November 15, 2016 GH17563-G

Subject: Response to City Correction Letter and Revised Basement Wall Designs,

1830 N. Blue Heights Drive, Los Angeles, California.

#### GEOLOGY AND SOILS REPORT CORRECTION LETTER

# **GEOLOGIC MAP**

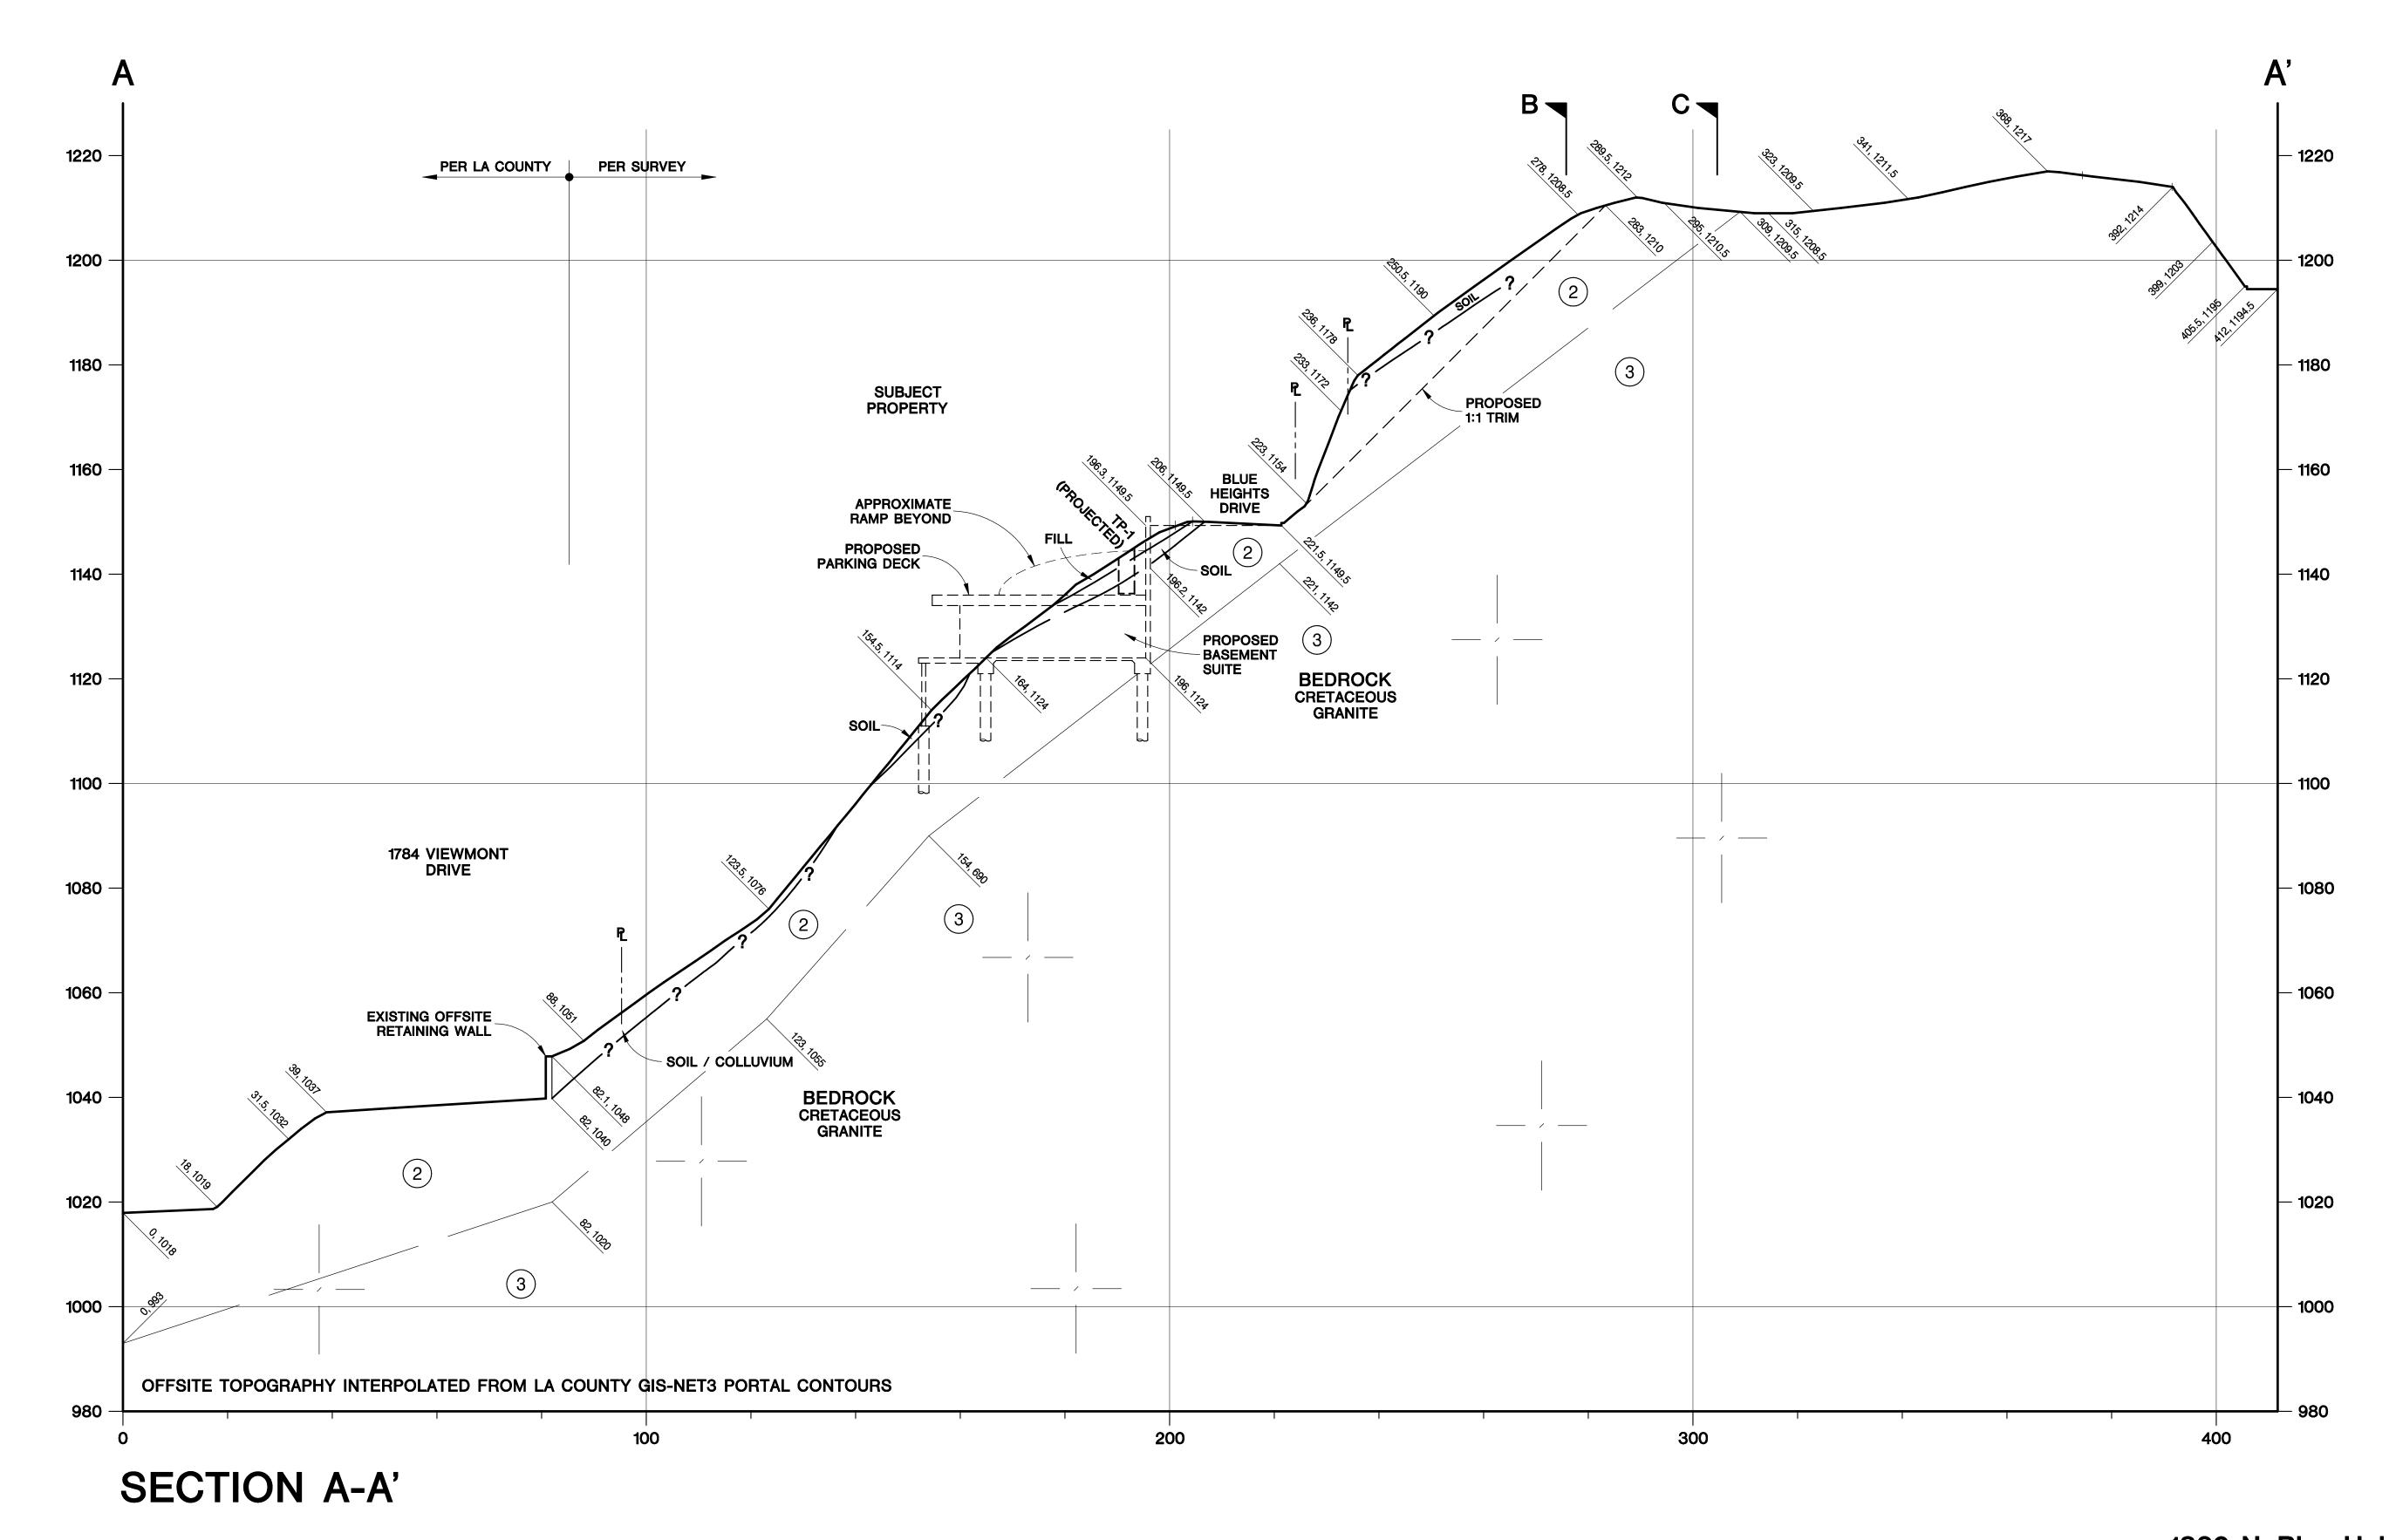
**Item 1**: Provide a geologic map that shows and labels all portions of the proposed project area including the limits of all proposed private street improvements. Where the proposed private street improvements are located on other than the subject property, provide appropriate legal descriptions and site addresses.

Item 2: Provide a geologic map that is based upon the conceptual grading or site development plans, to illustrate all proposed and existing contours relative to the planned grading and/or construction, along with all off-site slopes and conditions which could adversely affect the stability or safety of the site (7006.3.2). Provide topography for all offsite areas (including the roadway area from Sunset Plaza Drive to the main portion of the lot) above and below the proposed improvements from McLeod Drive to Viewmont Drive. Show and label the location and limits of the recommended options for 1:1 cut slopes and impact wall with 5 feet of freeboard along the uphill side of the private roadway (entire length). Show and label the location and limits of the recommended removal of the thin wedge of uncertified fill.

**Response:** The issue of the timing of the private street report has been discussed with the reviewers by Penny Flinn. We understand that the City is willing to condition permitting the residence on future approval of a private street report. Our firm will perform exploration and mapping along the private street once the plan is completed.

**Response:** The top of the proposed 1:1 trim is shown on the enclosed geologic map and sections A, B and D. It should be noted that minimum required trim is lower on Section B than Section A. We have shown the maximum extent of the cut on the Geologic Map and the minimum extent on the sections as this results in more conservative stability analyses. The extent of the slough wall required in the vicinity of Section C is shown on the Geologic Map. The slough wall is necessitated by the talus deposit. If the talus is removed and the slope trimmed to 1:1 after talus removal, the slough wall could be eliminated.

1830 N. Blue Heights Drive Los Angeles, California GEOLOGIC SECTION A

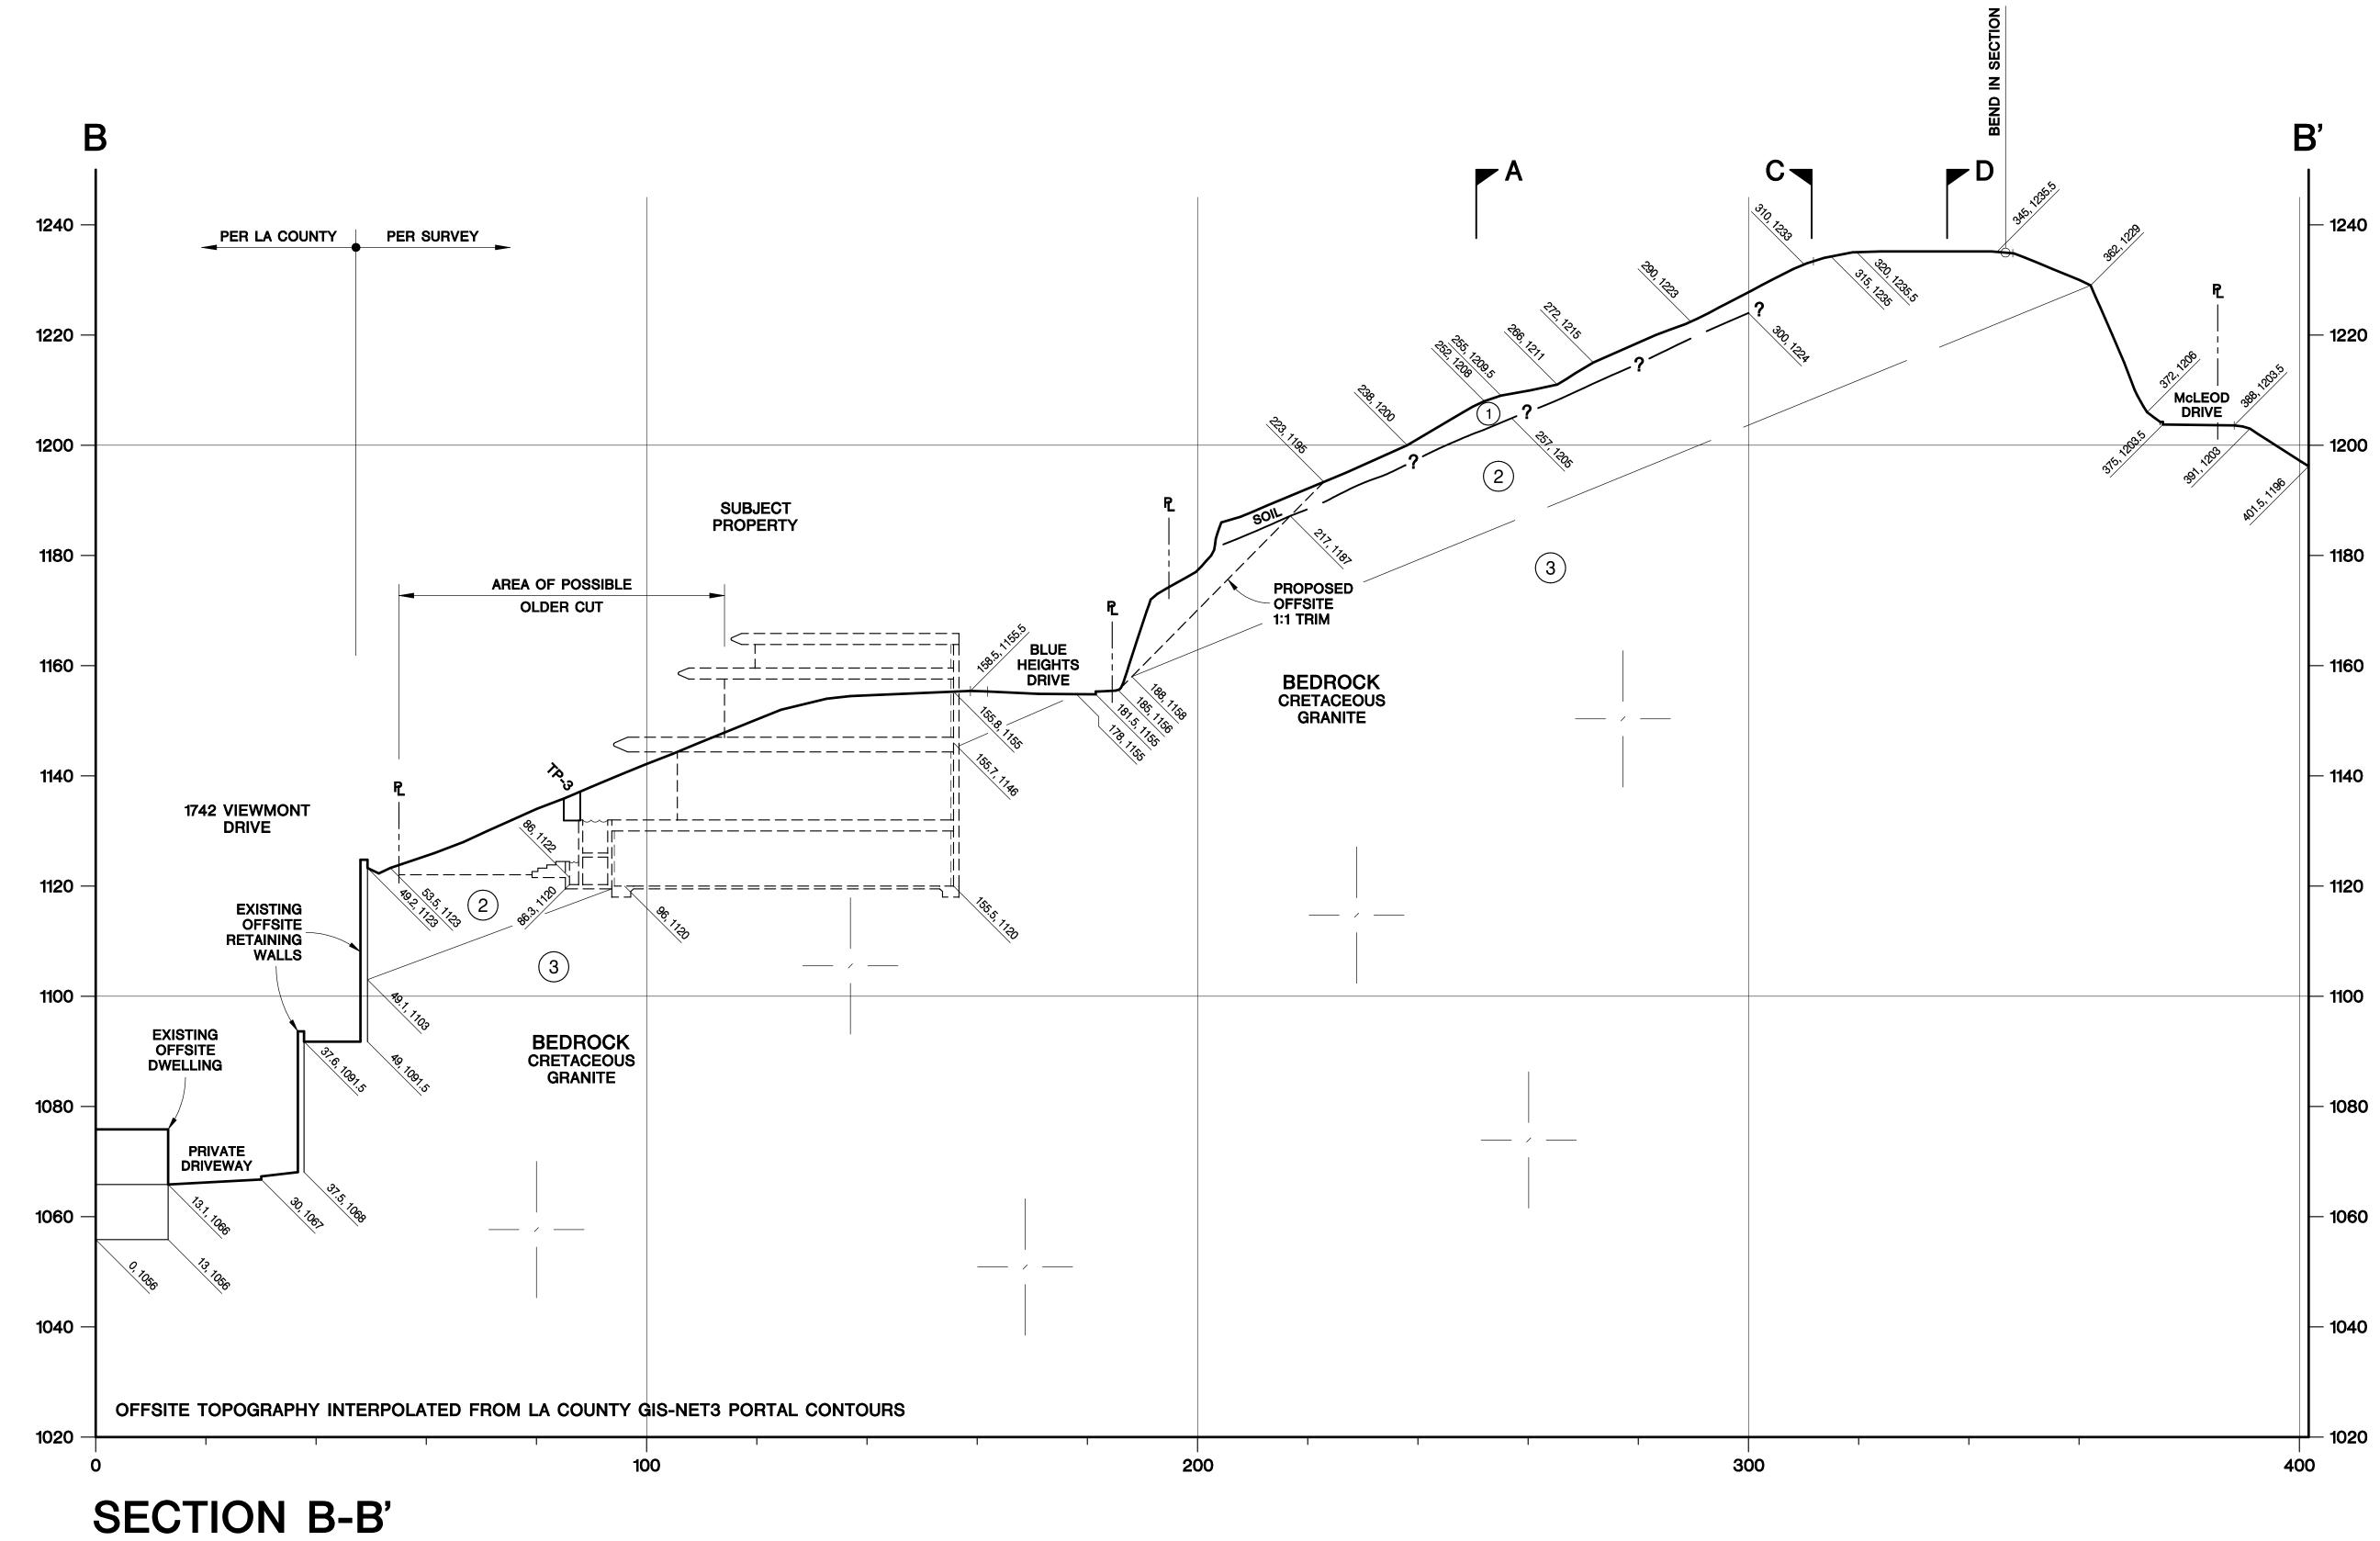
**Item 5:** As depicted in sections A and B, it does not appear that the proposed residence and bowling alley have the required building setbacks for slopes steeper than 1:1 from the plane drawn tangent to the slope at an angle of 45 degrees to the horizontal. Provide recommendations and revise the plan(s) and cross section(s) for providing the required building setback from the toe of the ascending slope as specified by Code Section 1808.7.1.

Item 7: The consultants indicate that the west-facing slopes above Blue Heights Drive (Section A) and kinematic analysis for west facing slopes do not have the required Code conforming factors of safety. Provide recommendations supported by analysis to stabilize the non-Code conforming slopes. Show the limits of the slopes with the less than Code conforming factors of safety.

**Response:** The over-steepened cut slope above Blue Heights Drive will be trimmed to a 1:1 gradient as shown on sections A, B and D. Therefore, the building will have the required setback to the ascending slope. The slope trimming has been agreed to by the offsite property owner.

**Response:** We have re-analyzed the kinematic stability of the cut above Blue Height Drive with the 1:1 trim. The west-facing trimmed slope will be kinematically stable. The only slope which is potentially kinematically unstable if trimmed to 1:1 is the south-facing slope. It is unlikely however that the planes that create an unstable wedge will intersect. In addition, a slough wall will likely be provided at the toe of this slope.
